**REPLACEMENT OF BLUE RIDGE PARKWAY
BRIDGE OVER INTERSTATE 26**

**Federal Project Number– NC_ST_BLRI_I26_NEPA
PMIS 221876**

**Value Analysis (VA) and Choosing-by-
Advantages (CBA) Study**

August 2016

Figure 3: Alignment 4

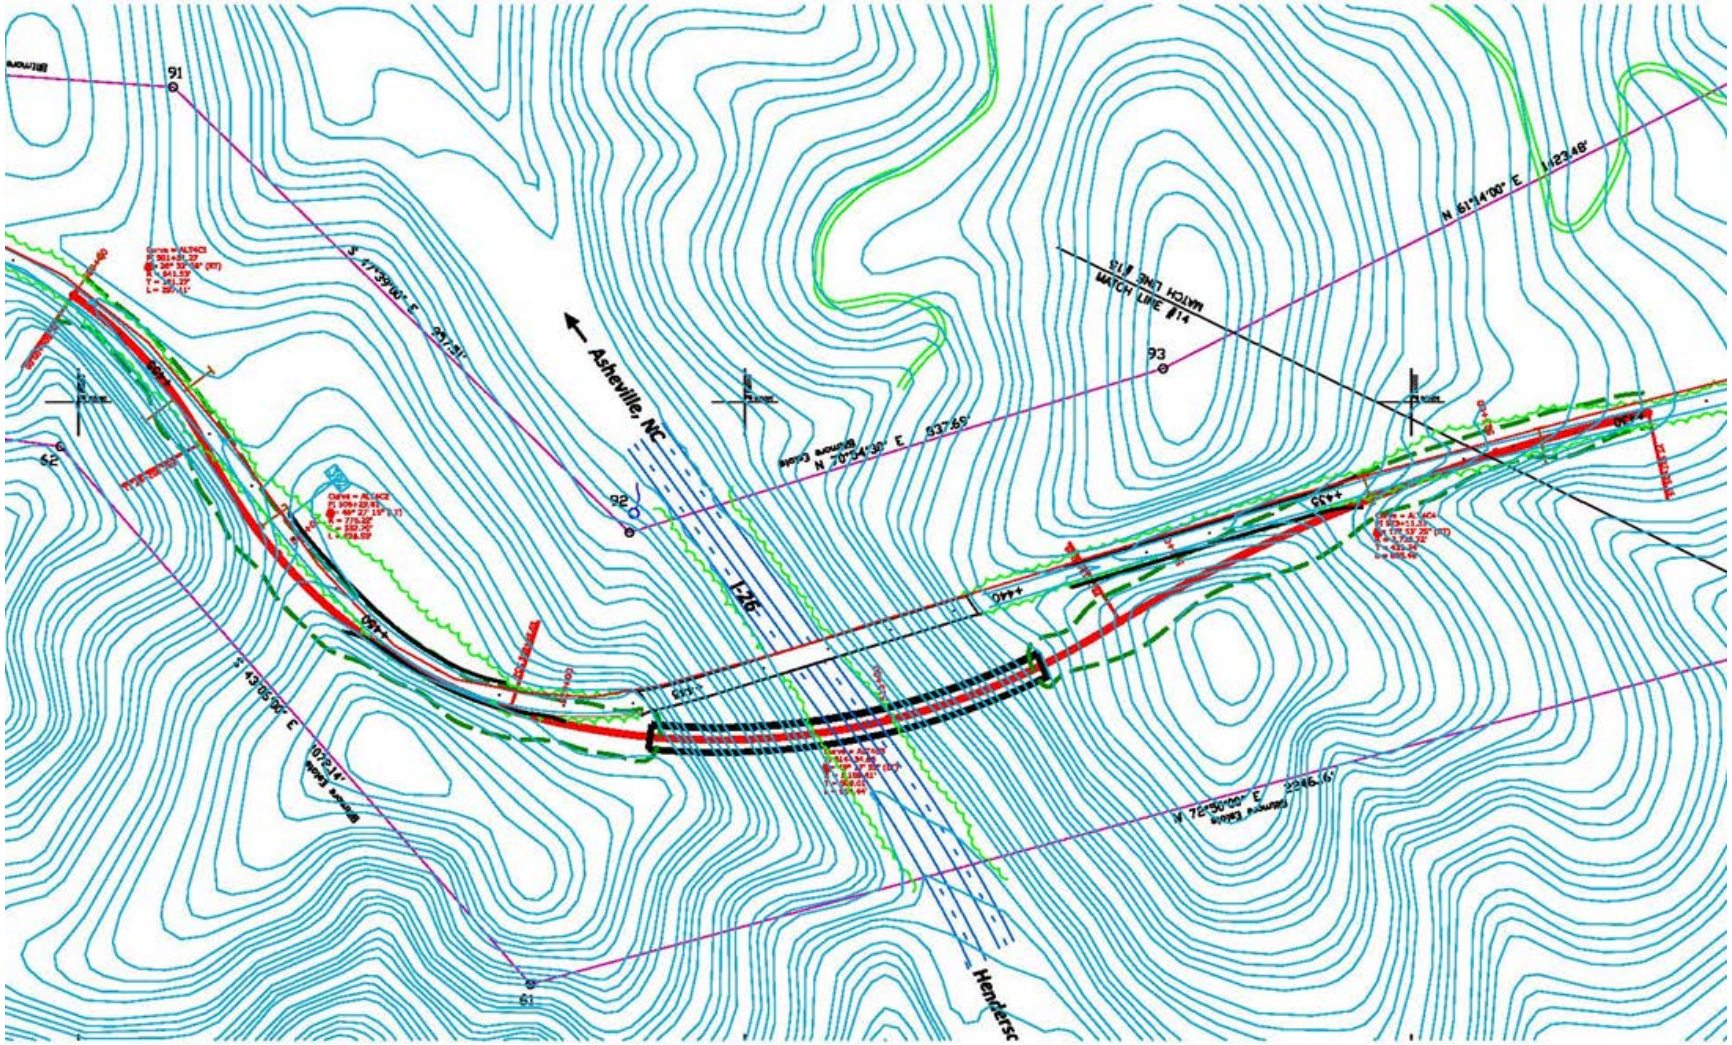
Alternative alignment 4 has the greatest total advantage. It would have the least impact on visitor experience, and would provide the greatest safety and operation and maintenance efficiency by avoiding a detour. It, as with alternatives 1 and 5, would have greater adverse effect on cultural and natural resources than alternative 7, however, initial consultation with the NCSHPO and field surveys of natural and archeological resource indicate that the impacts would be slight and/or could be mitigated. Alternative alignment 5 has somewhat less advantage than alternative 4 because of the sharpness of curves in the alignment and superelevation of the bridge. This was further discussed by the VA team as presented below.

Alternatives 4 and 5s' costs and advantages were compared further to determine a preferred. They both provide considerable advantage over alternative 7, and both cost much less than alternative 1. Alternative 4 provides greater total advantage than alternative 5, but would cost somewhat more (Figure 14). Alternative 4 has safety advantages compared with alternative 5, as discussed in the initial evaluation. The VA team conducted an additional side-by-side evaluation of the two alternatives as shown in Table 11 to further refine the evaluation. The two alternatives were further compared by 1) the ability to adjust alignment grades to tie into the bridge, 2) the degree of the new alignment's departure from the existing Parkway alignment, and 3) constructability based on topography. For all factors, alternative 4 would be preferred. Based on this evaluation, alignment alternative 4 is the recommended alignment.

Following the VA workshop, EFLHD refined the vertical and horizontal alignments of alternative 4. The refined Type, Size and Location (TS&L) were presented above in Figures 6 and 7. The revised preliminary plan and profile is also presented in Appendix C.

Figure 5: Alignment 7

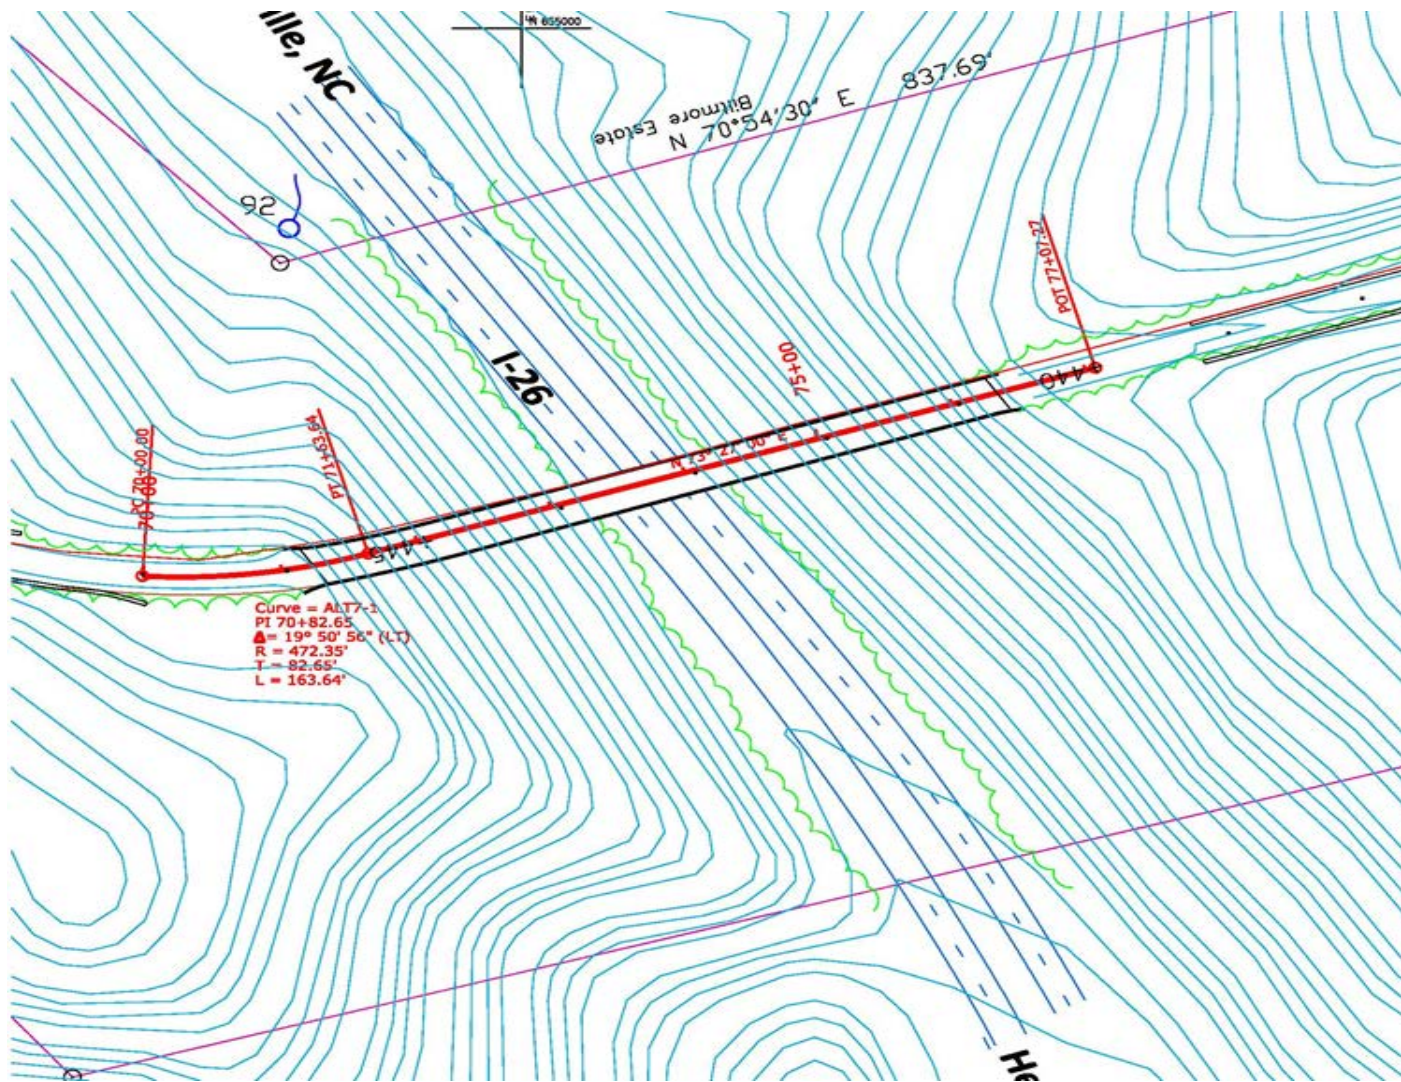
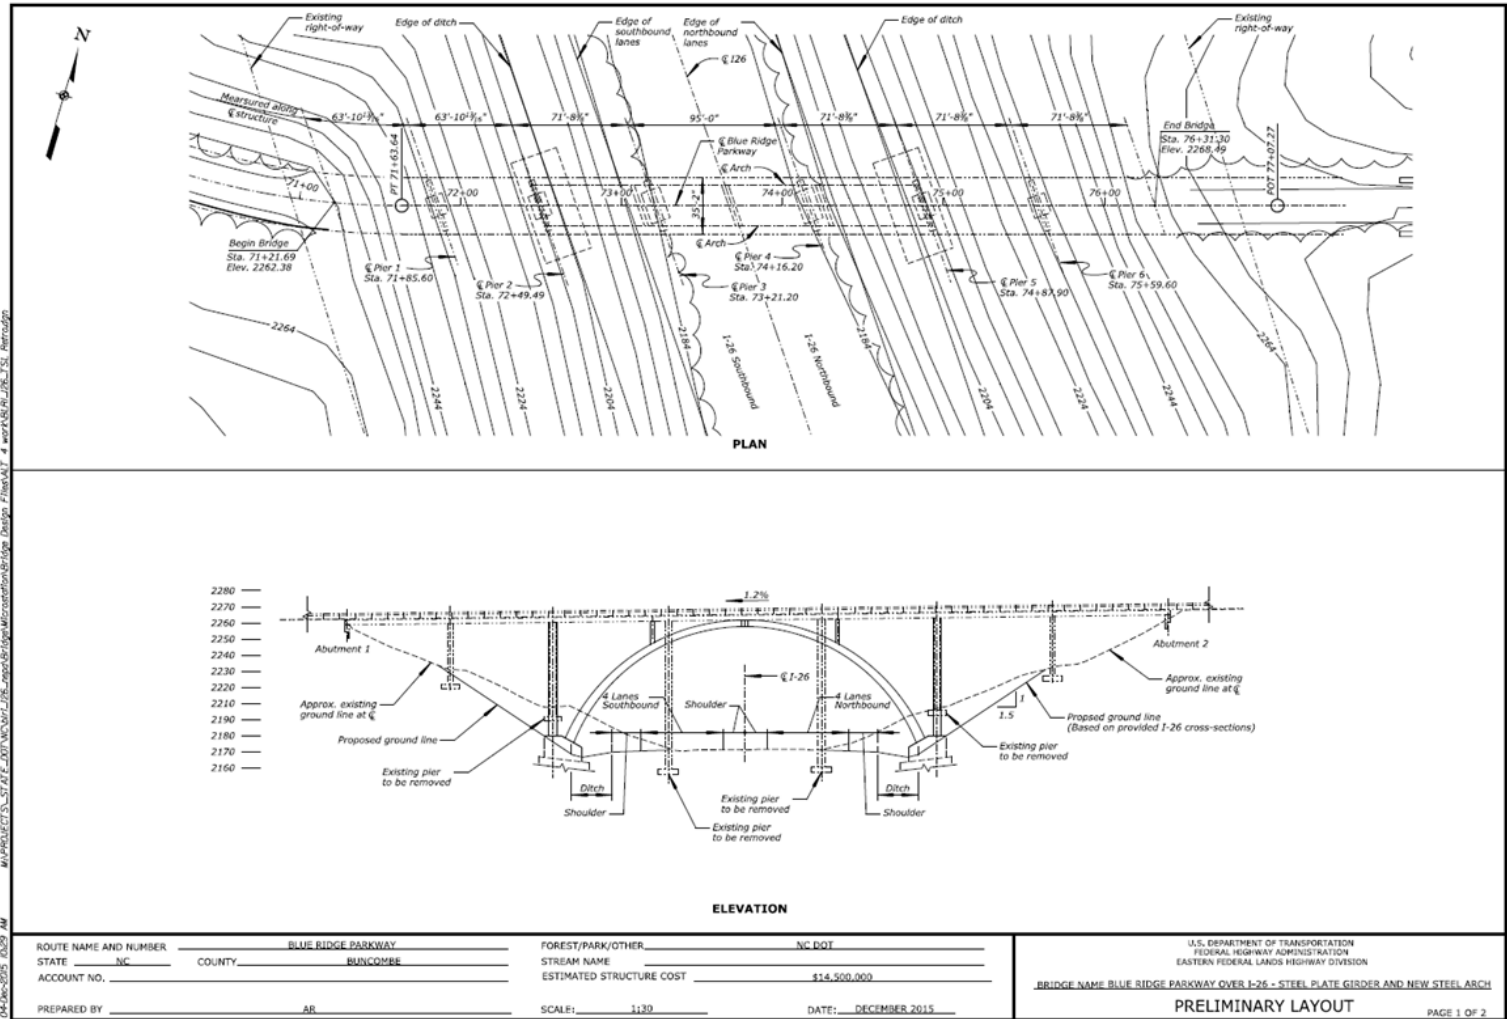
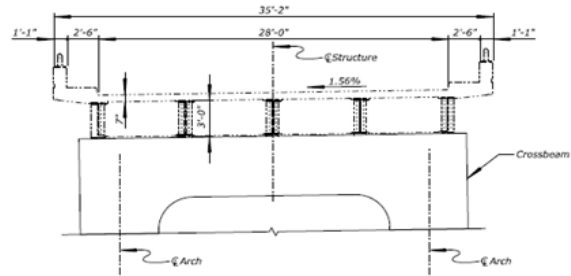
Prior to the full evaluation of the alternatives, the VA discussed the feasibility of retrofitting the existing bridge in-place under alternative 7.

The retrofit option would have a very high life cycle cost. Initial construction costs would be somewhat less than the other alternatives, however, due to the age of the bridge full bridge replacement would be required within 20 years. Over the full 75-year service life used in the life cycle cost analysis, this would result in up to a 50 percent increase in total life cycle cost compared with other alternatives (Table 1).

There are no construction advantages over a new bridge on the alternative alignments. Installation of the arch segments would require significant construction activity from I-26 to deliver and raise materials. This could require unacceptably long closures and impacts on I-26.

The ends of the arches would unacceptably have to be aligned within the drainage ditches of the I-26 widening, and would only provide clearance for 8 lanes, not the required 10 lanes as mandated.

There may be some cultural resource advantage to maintaining the existing alignment and elements of the existing bridge. The addition of an arch, however, would alter the character of the Parkway Bridge as viewed from I-26.

For these reasons, the VA dismissed the retrofit option from further consideration. If alternative 7 was selected as the preferred alignment, only a new concrete segmental or steel girder bridge would be considered.

Figure 12. Kansas Corral Rail

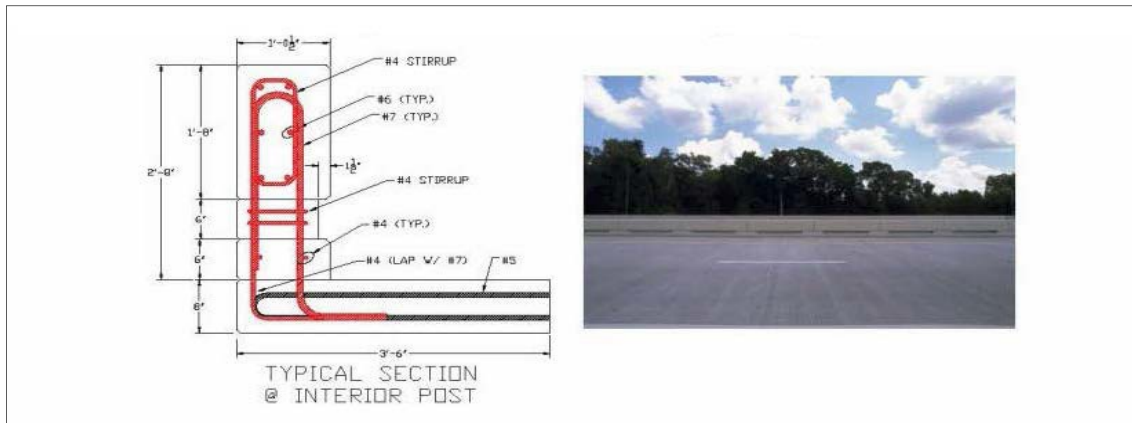
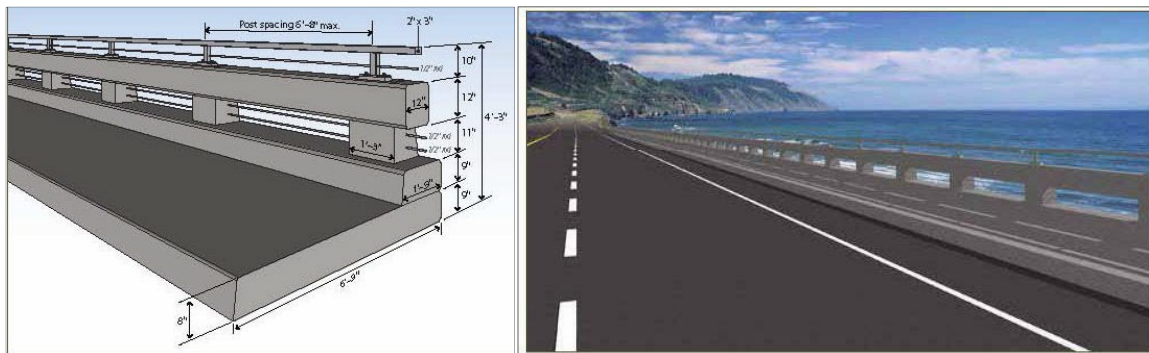
Bridge railing - The VA team evaluated the performance of two bridge railing options: Caltrans Type 80 and Kansas Corral rail. The evaluation was based on five evaluation factors: 1) Screening visibility of I-26, 2) Ability to divert drainage, 3) Aesthetics, 4) Ability to integrate stone guard walls, and 5) Ability to integrate hand rails. In all five factors, the Caltrans Type 80 rail was preferred and is recommended as the preferred railing type.

Figure 15. Asheville Corridor Access Map and MP 392.1 Site

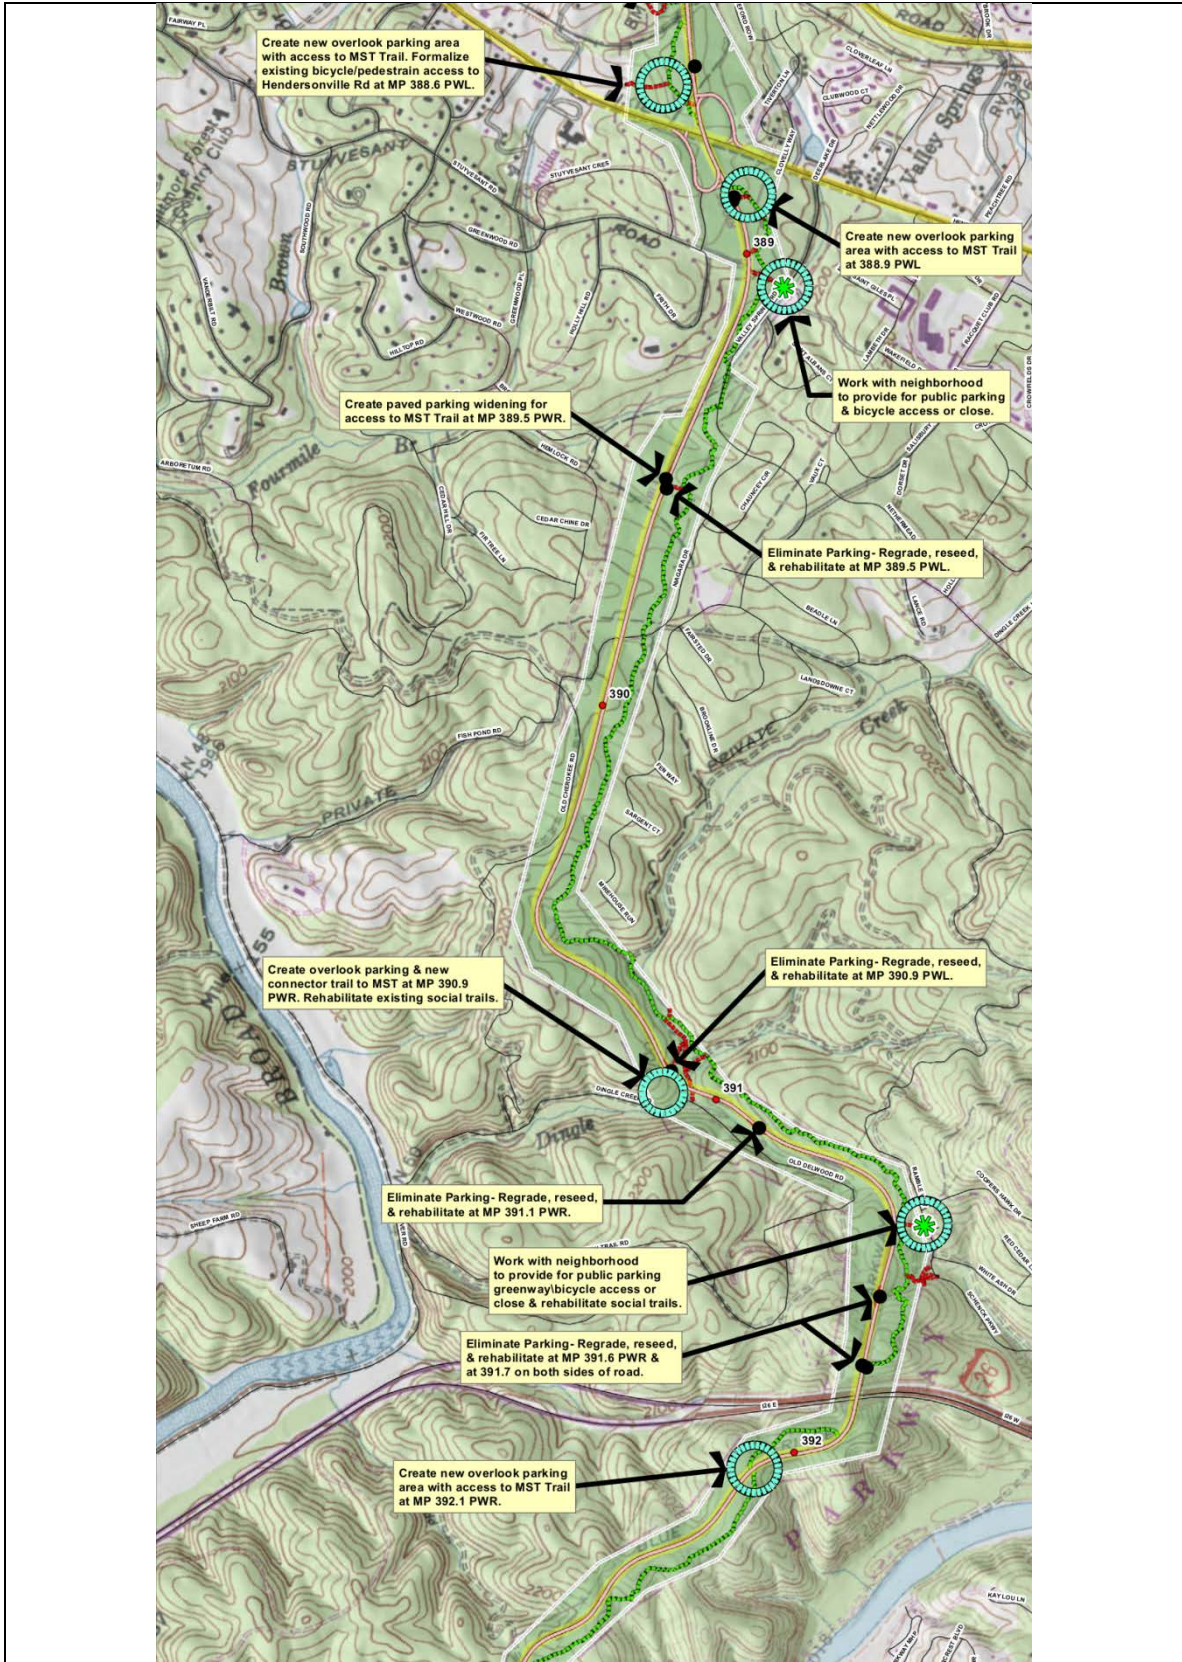
The Parkway is completing a comprehensive study of the Asheville commuter zone and Mountains-to-Sea Trail access (Figure 15). This study is an analysis of existing gravel pull-off areas that are heavily used by hikers and bicyclists as parking facilities along the Parkway. This includes a study for construction of new and restoration of existing gravel pull-off parking areas within the vicinity of the existing I-26 bridge.

Actions at MP 392.1 would include grading and constructing an asphalt-paved parking area on west side of Parkway. The location for parking area would provide safe sight distances for motorist to and from parking area. The parking area would provide space for up to 8 vehicles. The adjoining social trails would be improved to provide official trail connections.
